ADDENDUM #01 11-04-2026

NEOMED
Library Renovation

HAI PROJECT NO. 26028.000

FLOOR PLAN - LEVEL 1

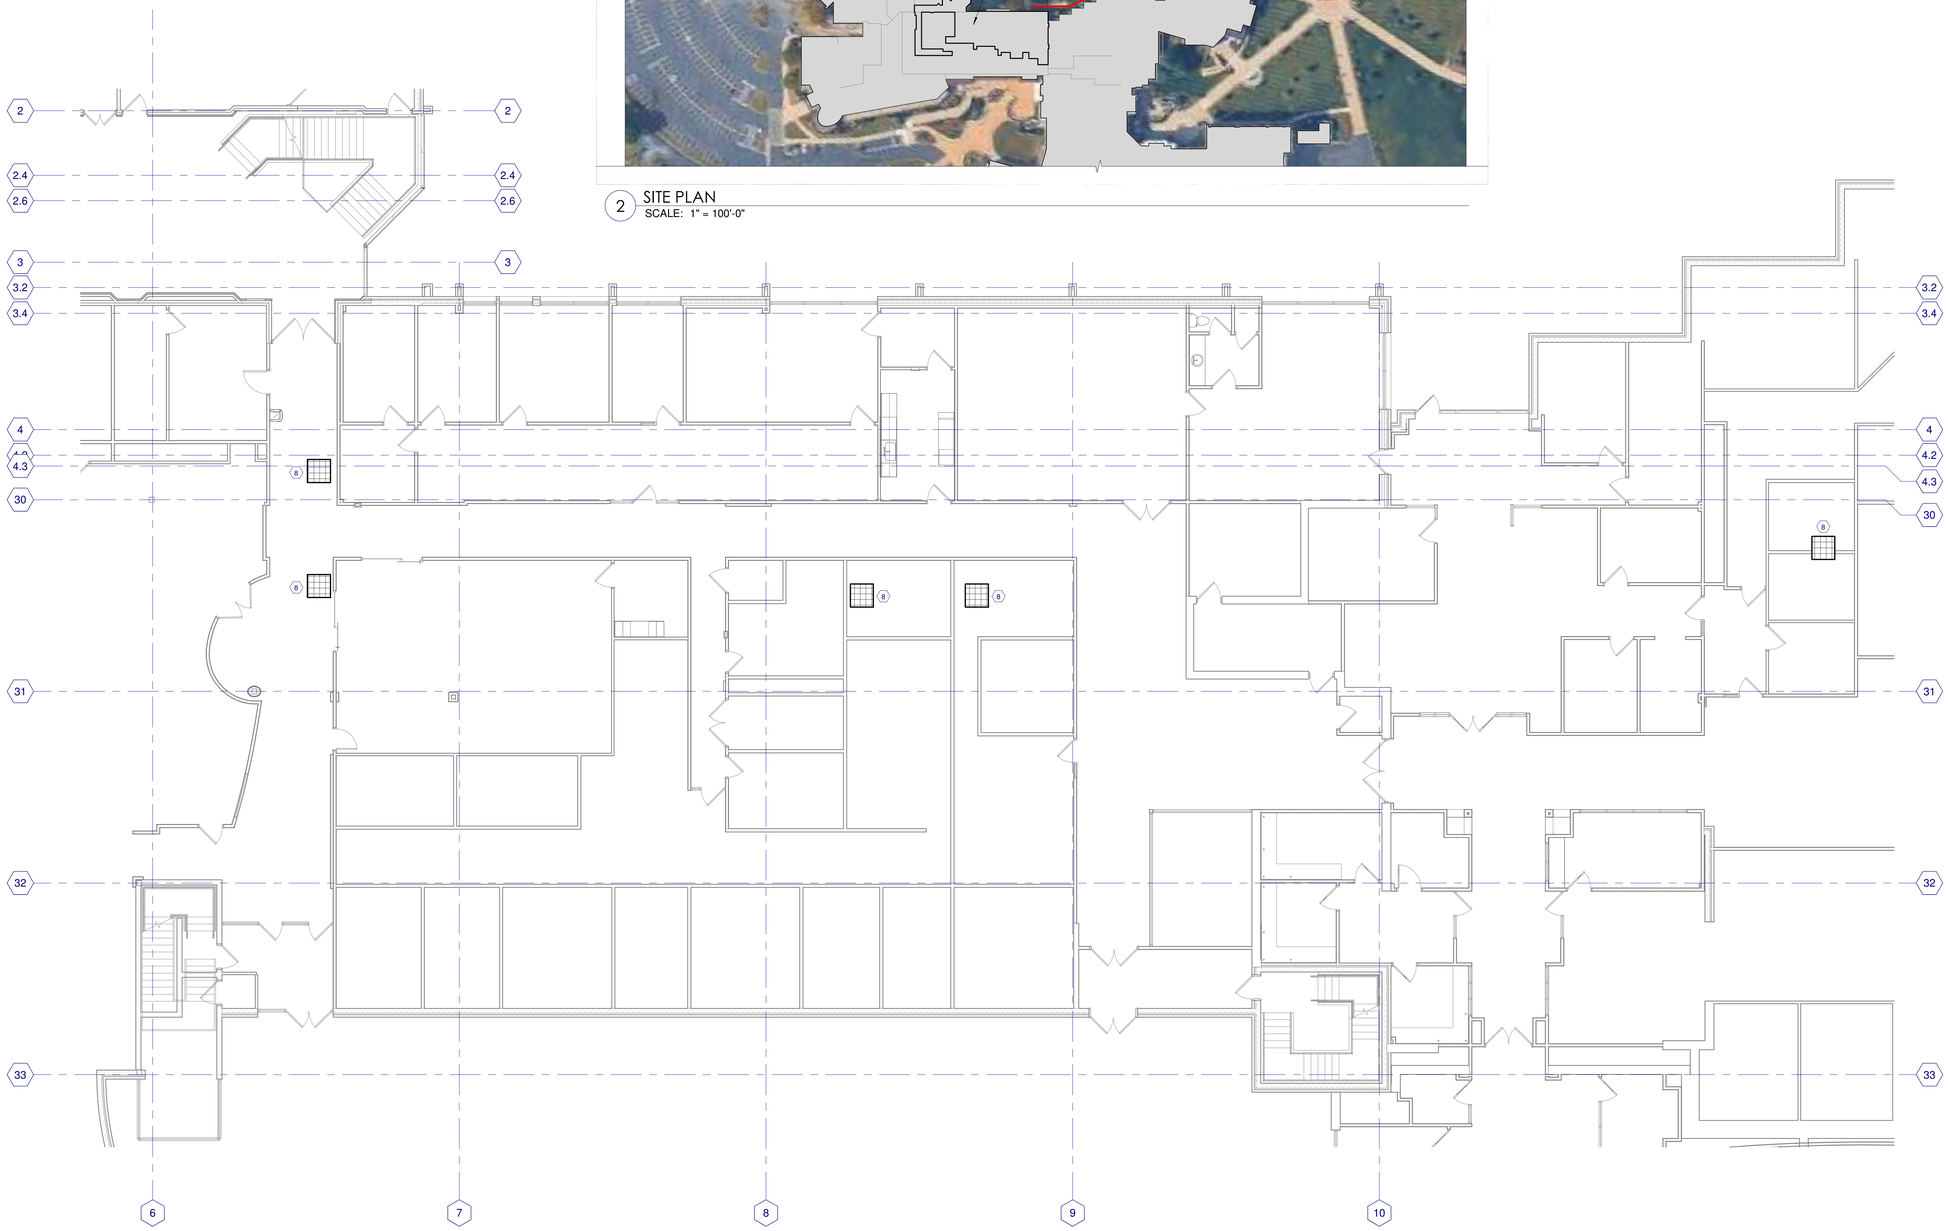
1. Sheet A0-0:
   a. Updated drawing index with added sheet A2-1.
2. Sheet A1-2:
   a. Identified location where materials can be removed from and brought into project area.
3. Sheet A2-1:
   a. Added sheet showing layout of first floor plan below work area.
   b. Added vicinity map showing suggested location for dumpster and path between dumpster and work area.
4. Sheet A2-2:
   a. Modified enclosed study room layout.
   b. Added floor outlets.
5. Sheet A3-2:
   a. Modified ceiling layout based on change to layout of study rooms.
6. Sheet A9-1:
   a. Modified carpet layout based on change to layout of study rooms.
7. Sheet FP1-1:
   a. Added note and new sprinkler head for new interior study room.

1 / E1-3 **POWER AND SYSTEMS PLAN - LEVEL 2**
1/8" = 1'-0"

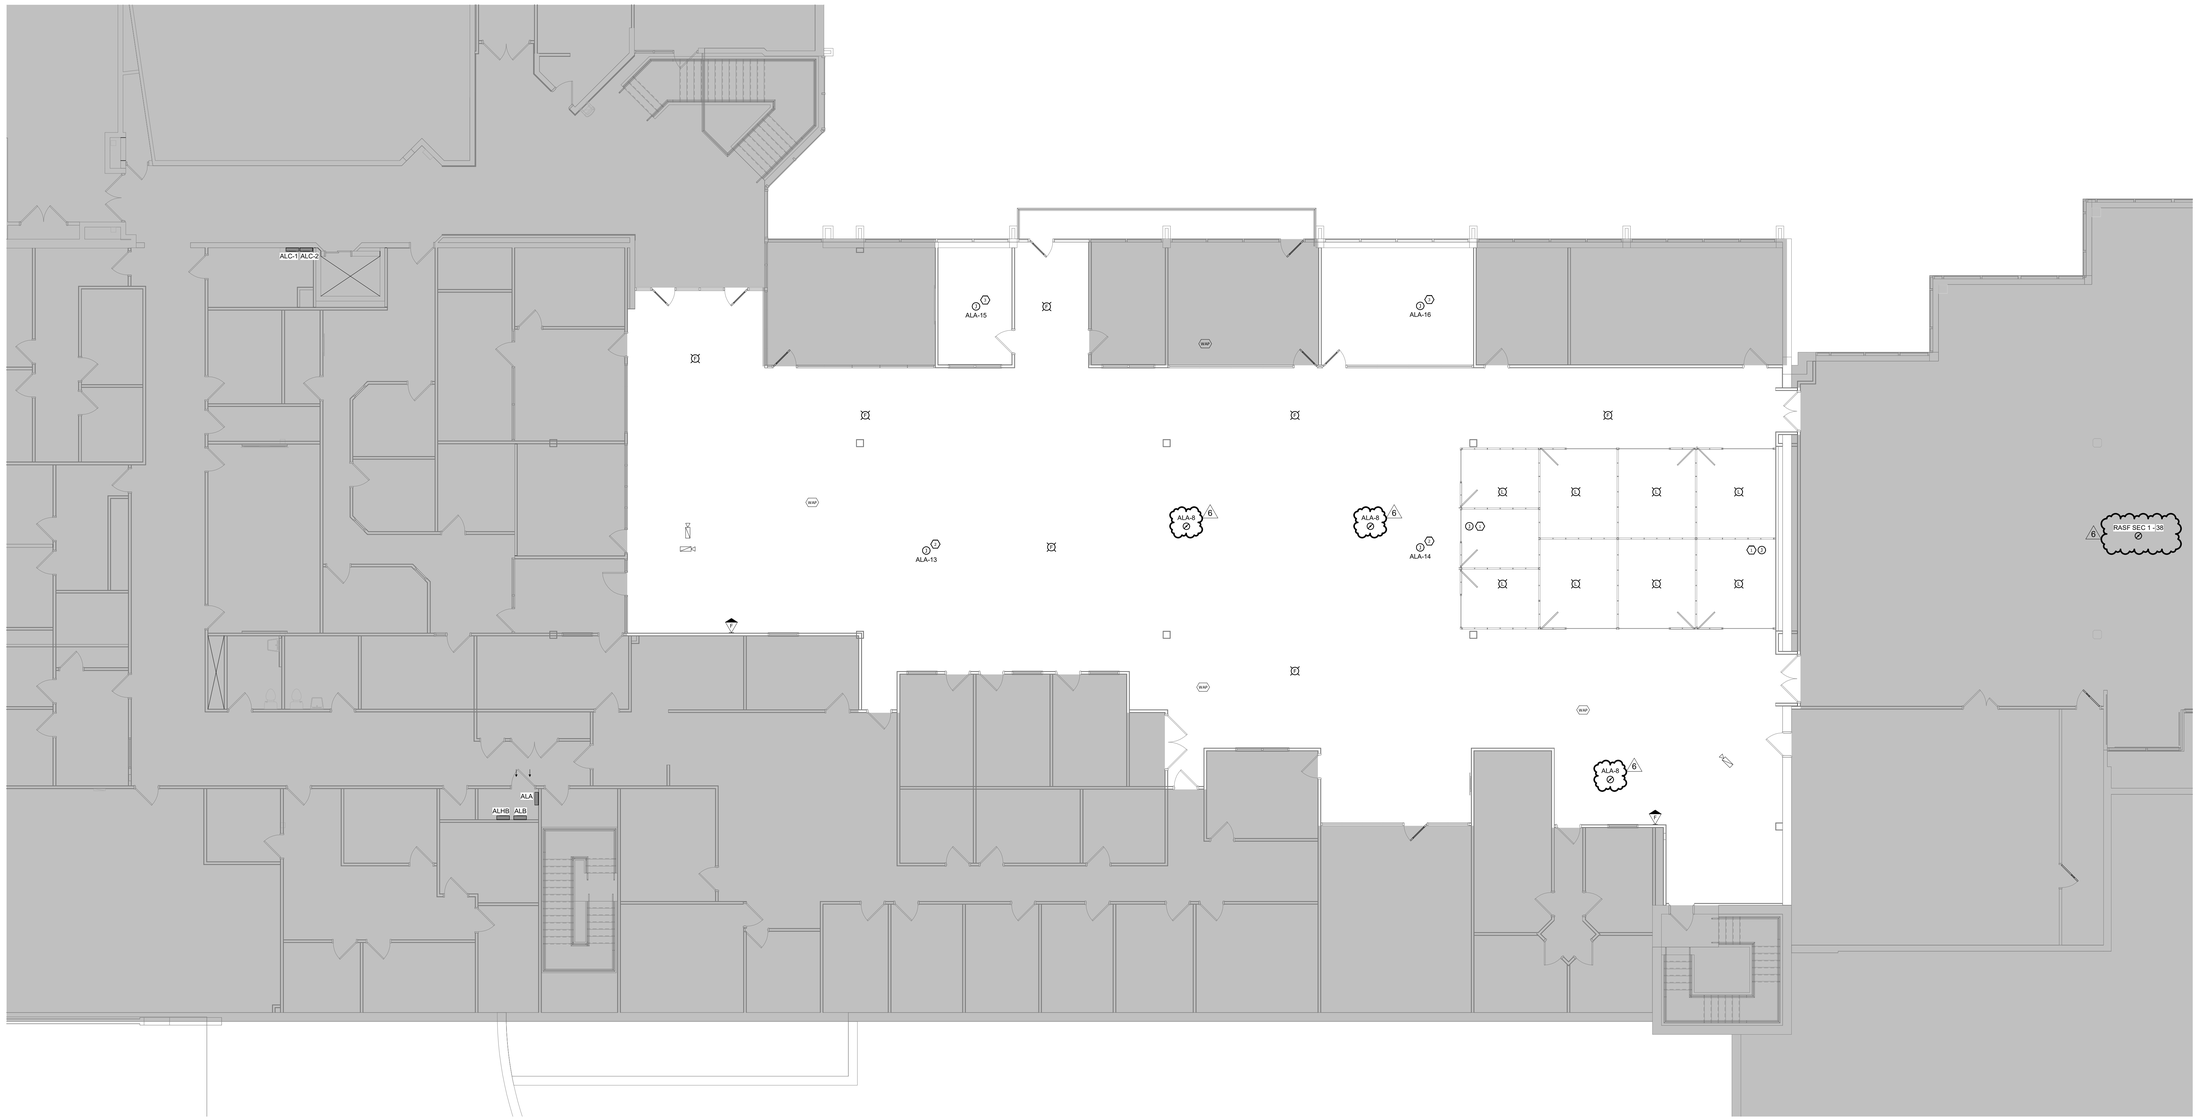
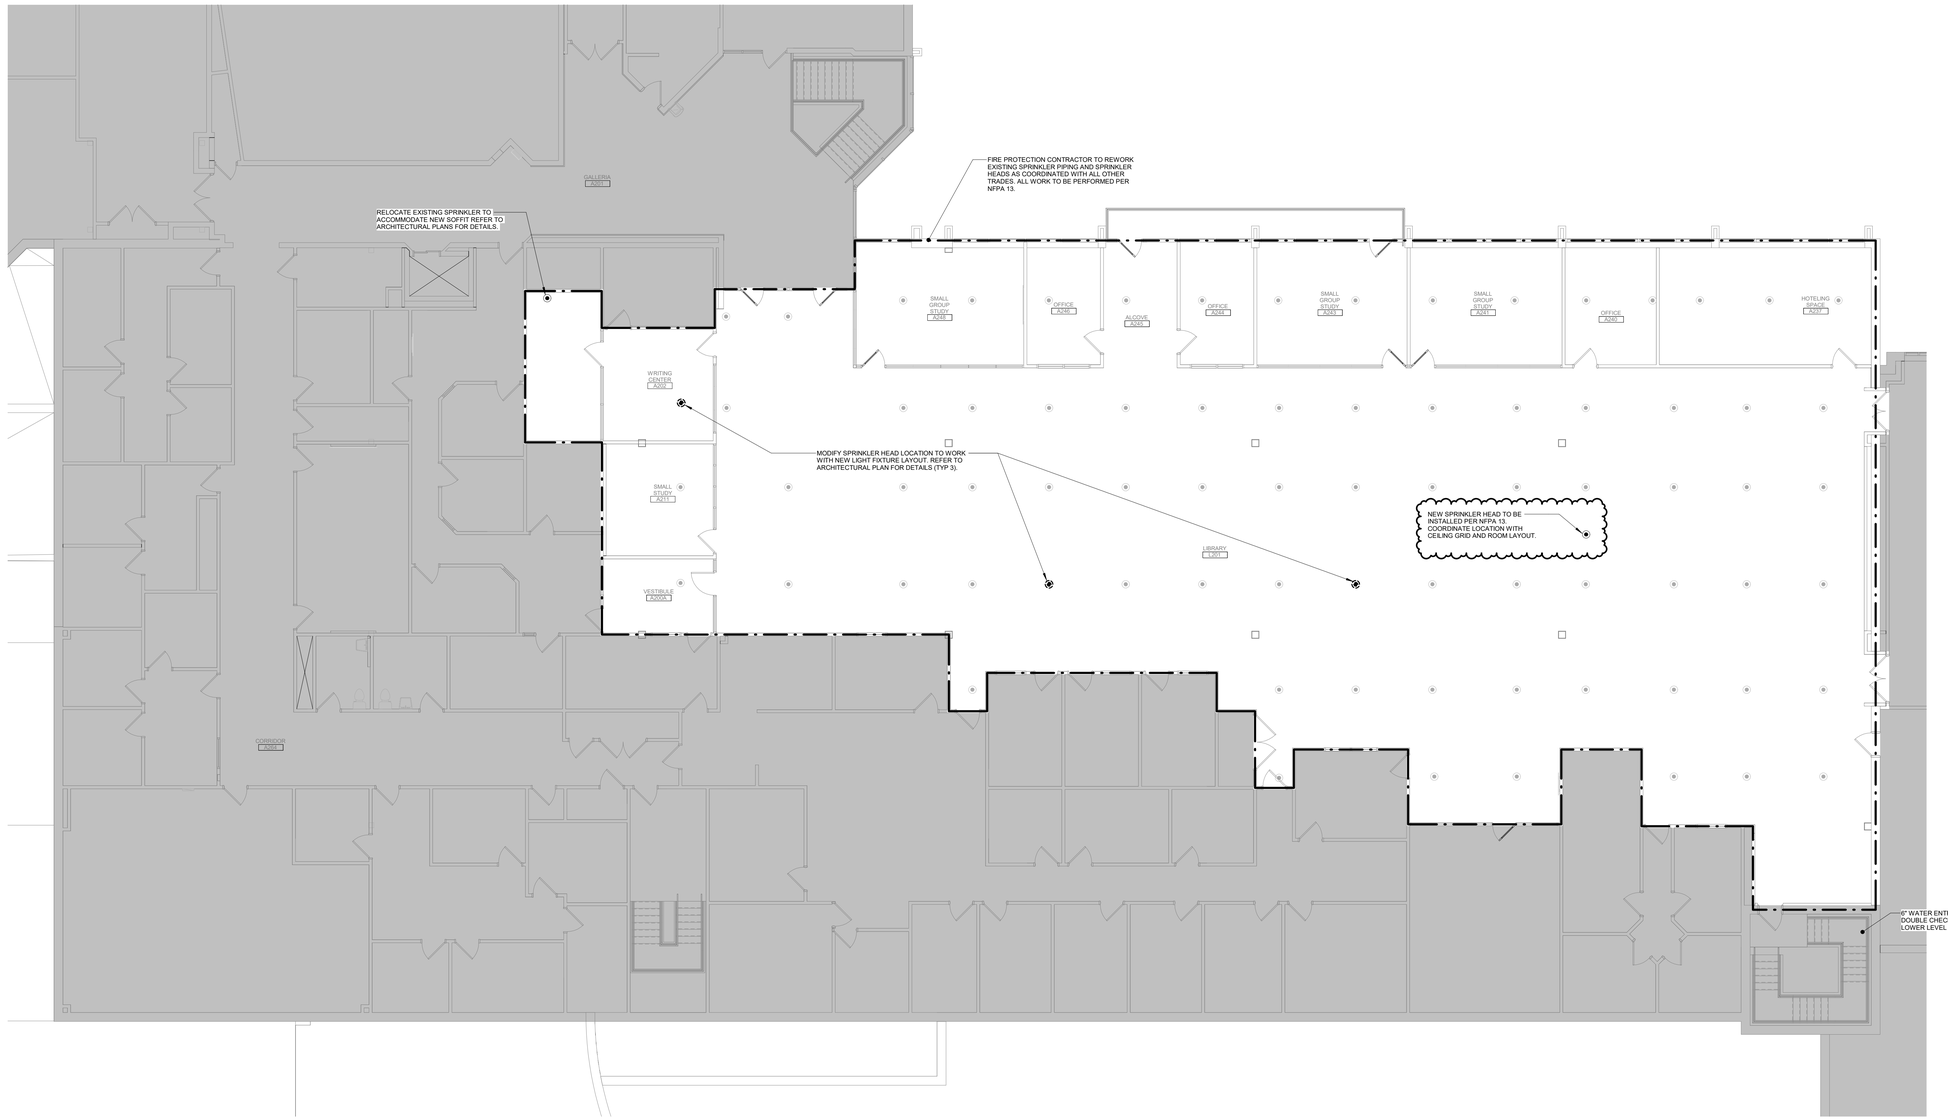
8. Sheet M2-1:
    a. Modified ductwork for new study room layout.
    b. Added new AL6 diffuser and TL10 grille.
    c. Modified diffuser CFM values for new layout.
9. Sheet M3-2:
    a. Modified TB-14 max CFM airflow from 800 to 850 CFM.
10. Sheet E0-1:
    a. Added RASF Panel Schedule for Quiet Study Area poke through.
    b. Updated symbol legend.
11. Sheet E1-2:
    a. Updated lighting layout and controls to match updated floor plan.
    b. Added light fixture designation and controls diagram details.
12. Sheet A1-3:
    a. Added poke throughs to Library and Quiet Study areas.
